SAN FRANCISCO PLANNING DEPARTMENT

MEMO

TO: Architectural Review Committee (ARC) of the Historic Preservation Commission (HPC)

RE: **Review and Comment: 554 Fillmore Street, Sacred Heart Church**
Case No. 2015-005890DES

SEISMIC STRENGTHENING

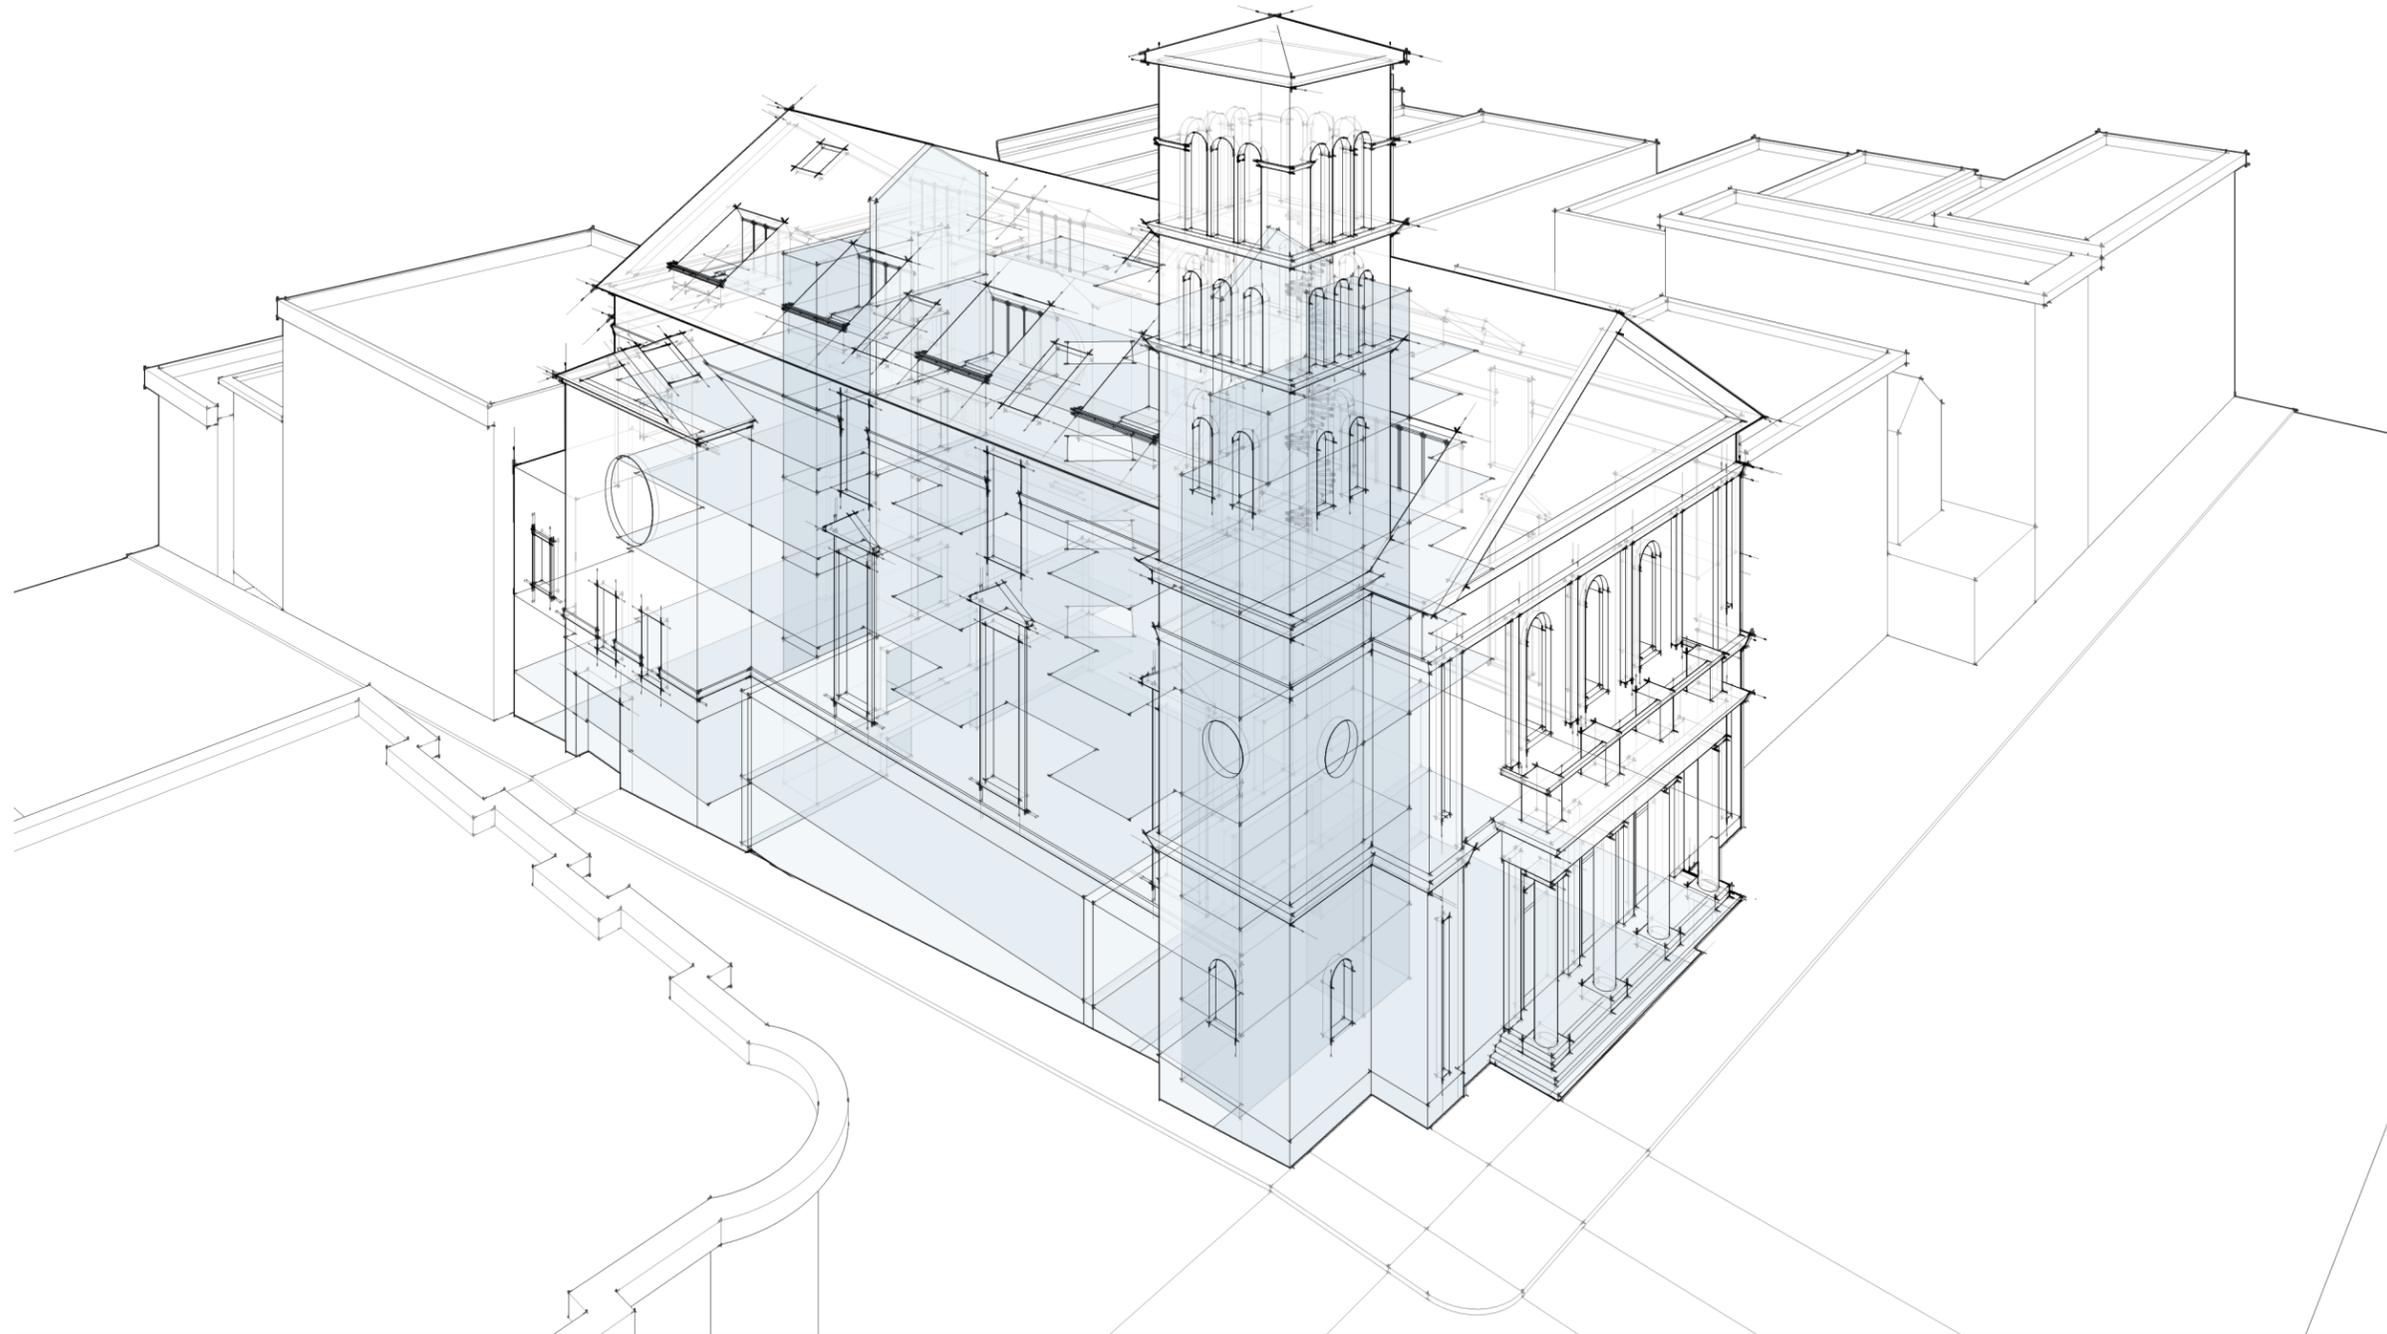
The Department supports the proposed restoration and stabilization of the campanile via shear walls and bracing as the proposal appears to be the least invasive and most sensitive treatment of the structure. The proposed glazing at the belfry should be set back from the original columns to retain the appearance of the depth of the space from the public right of way.

EXISTING ROOF PLAN

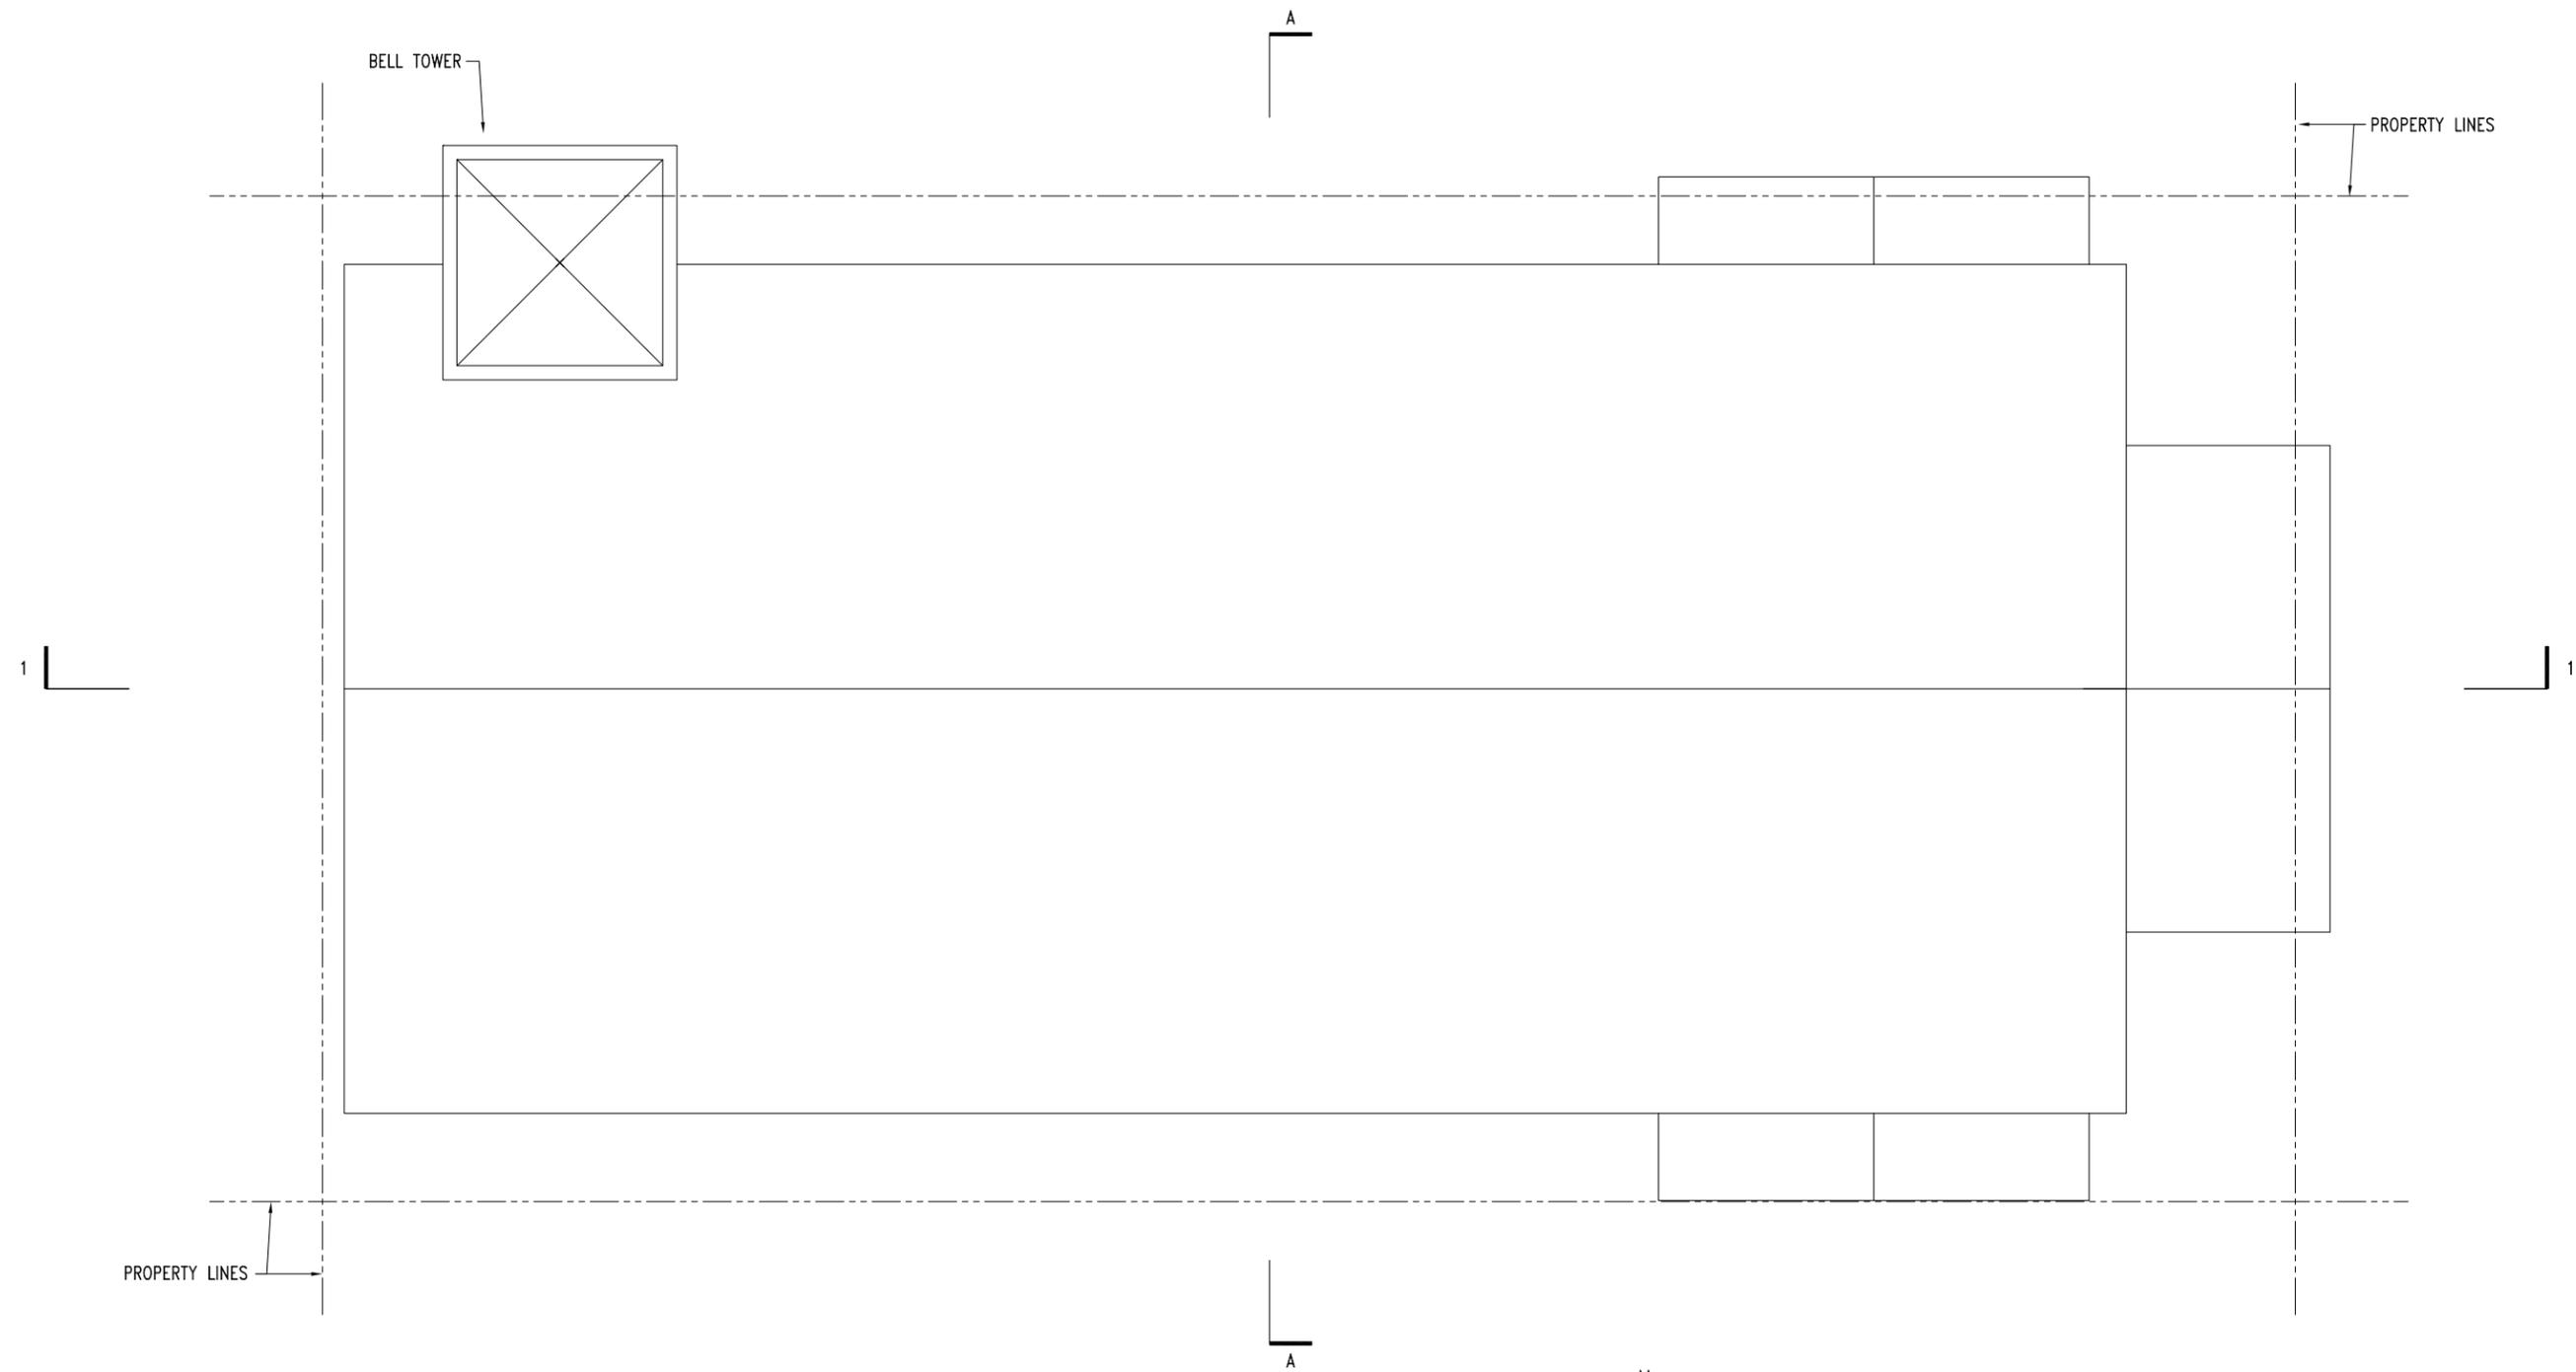
Roof: As the existing gable roof is highly visible from the street and many other vantage points throughout the southern and eastern parts of the city, the new inset terraces proposed at the northern portion of the gable roof and new openings at the southern portion of the gable roof would be visible. The project sponsor has pulled the new terraces in to reduce the projection of balcony railings above the slope of the roof. Depending on overall visibility, some new openings within the roof may be acceptable provided that a sufficient amount of the roof and its materials remain so that the slope of the roof and its historic form may be understood when viewed at a distance.

The Department recommends reducing the number of proposed roof terraces to no greater than four, as the upper unit does not require more Useable Open Space per Section 135 of the Planning Code. This would reduce the overall removal of original fabric at the roof while maintaining the access to light and air for the unit.

○ NORTH ELEVATION

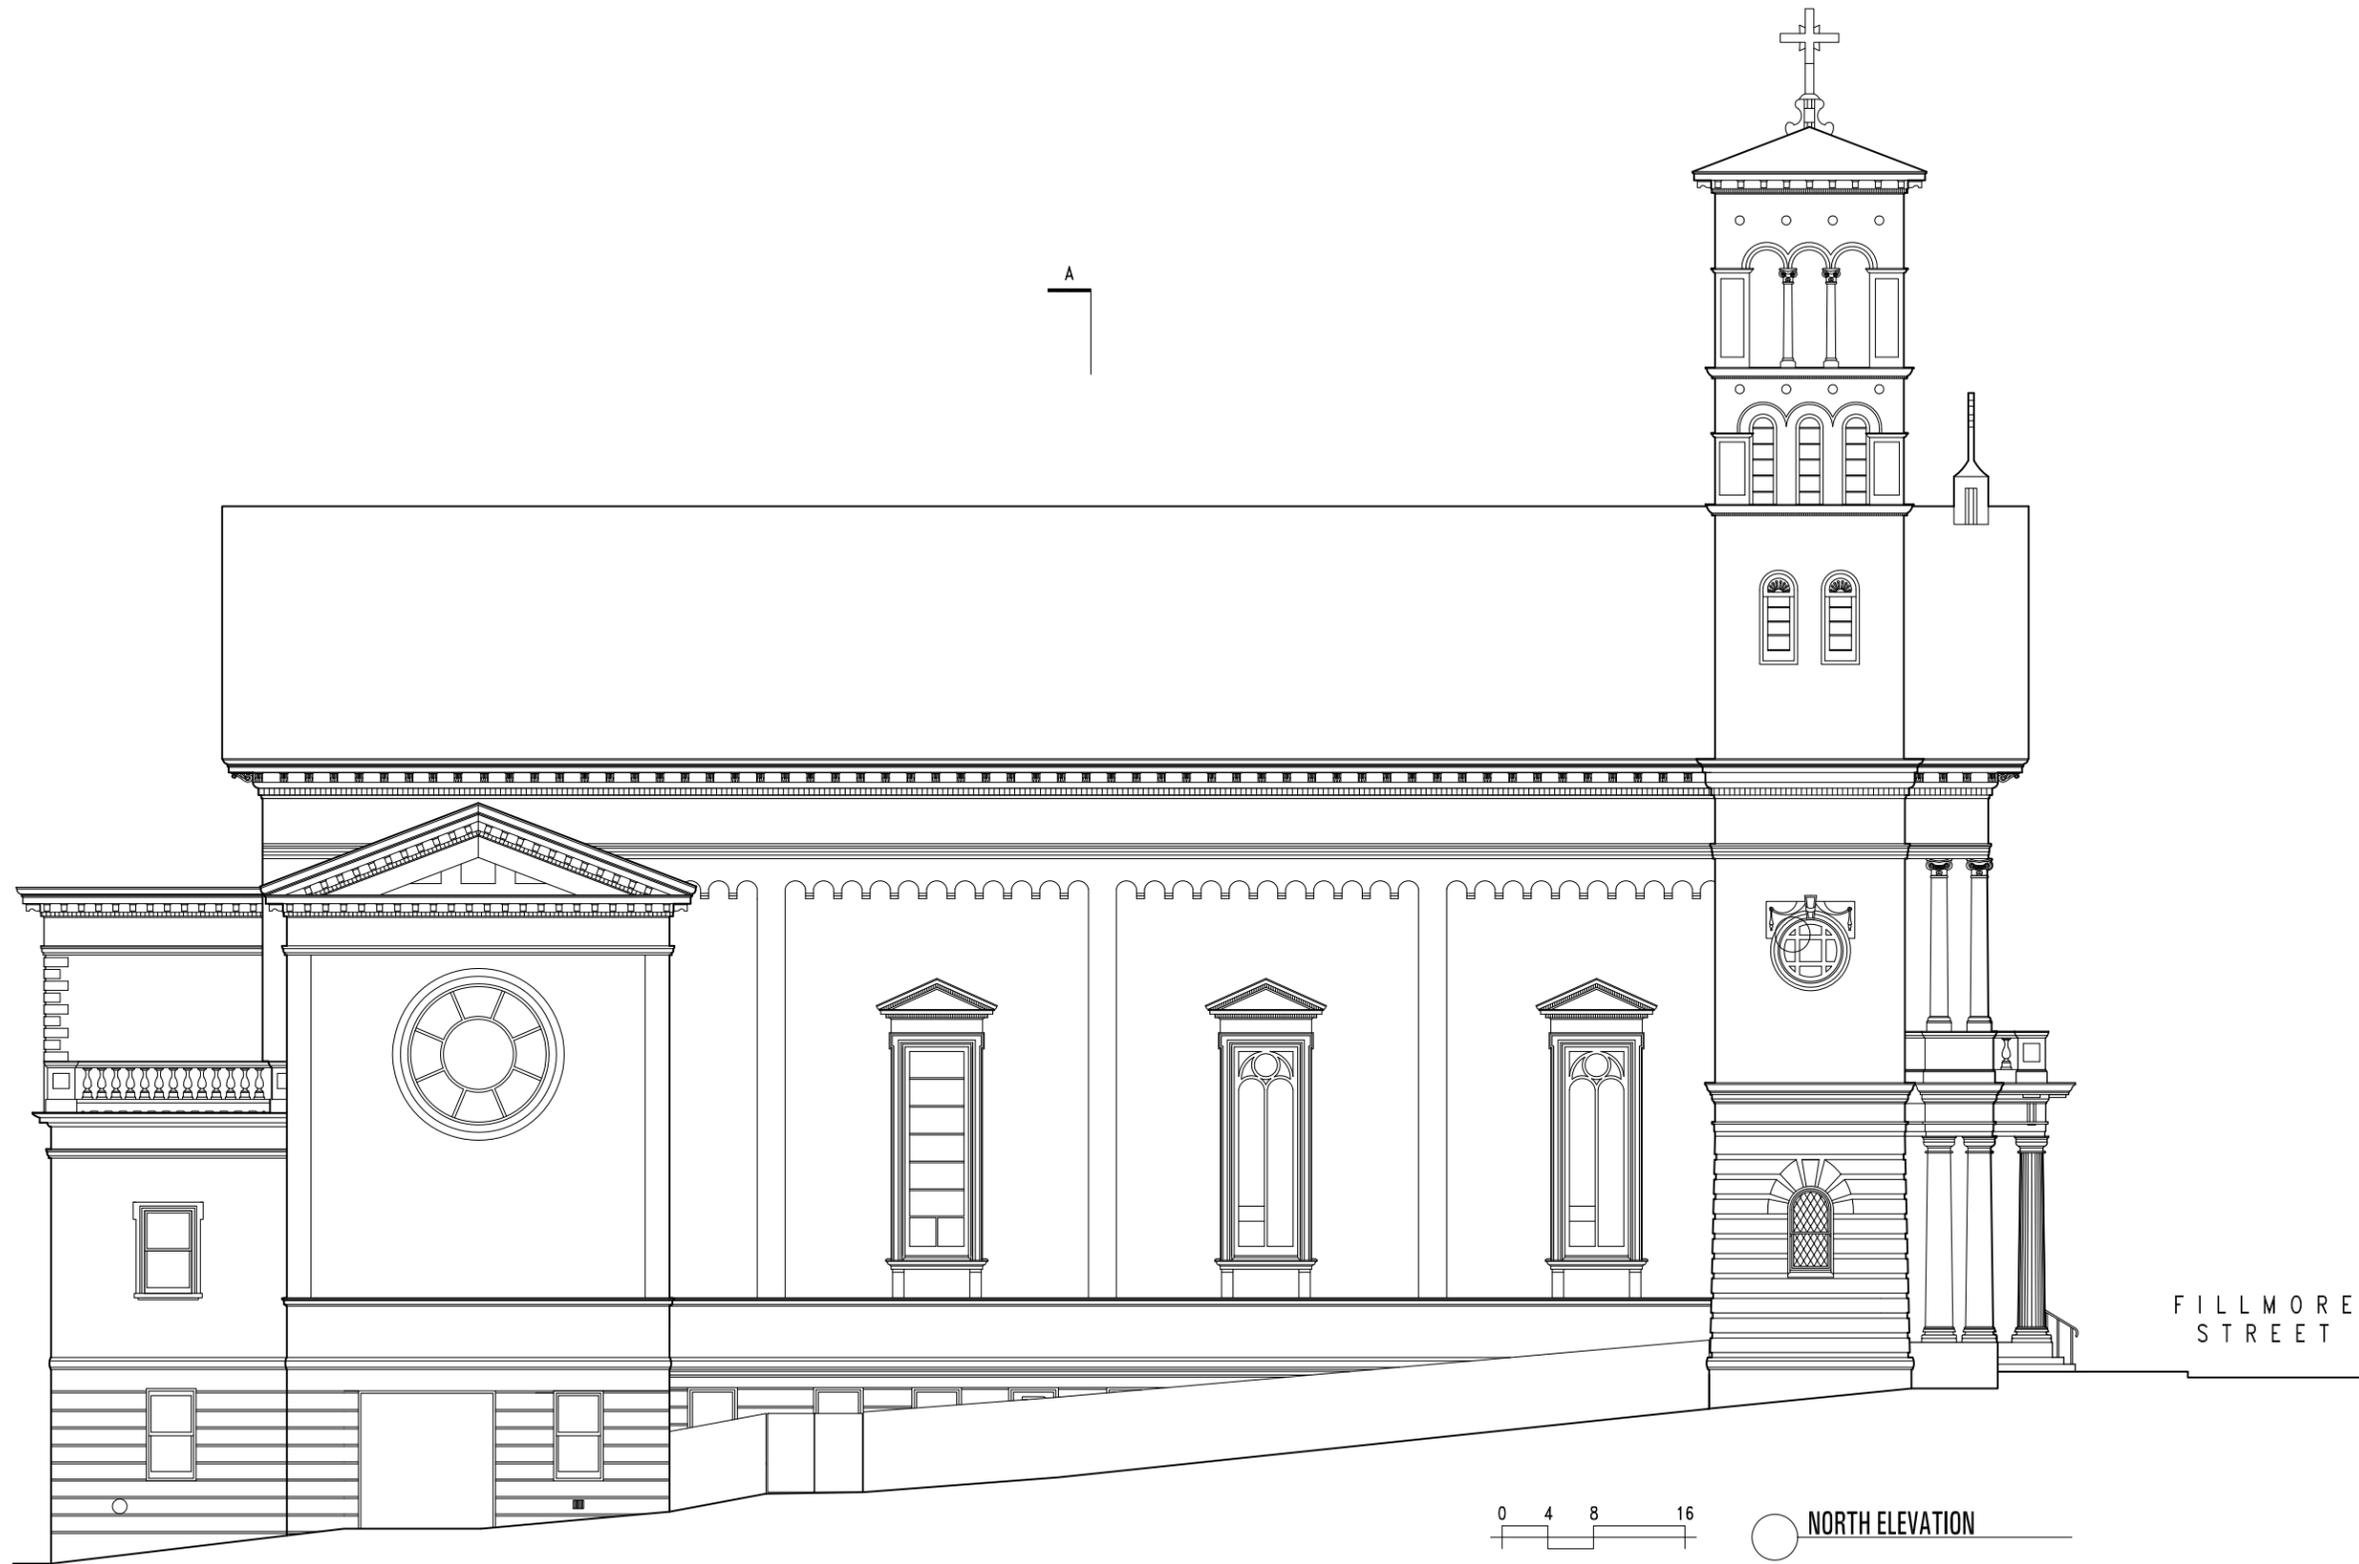
North elevation: The new window openings proposed for the north elevation do not appear to be appropriate in scale for the north elevation and do not appear to conform with Standards 2, 5, 9, or 10. While the proposed lightwell windows above the stained glass relate in their width and verticality, they interrupt the brick detailing and offset the proportions of the Fell Street façade.

The Department would encourage retention of the stained glass windows in place, particularly on the north façade due to its high degree of visibility. If removal is deemed necessary for light and air, staff recommends installation of a patterned glass to reference the original treatment. Additional information is required on the required area of glazing for the proposed uses under the Building and Planning Codes. No program has been provided to outline proposed interpretation measures or re-installation of the windows. Staff finds the proposed restoration of the rose windows in the transepts to be compatible with Standards.
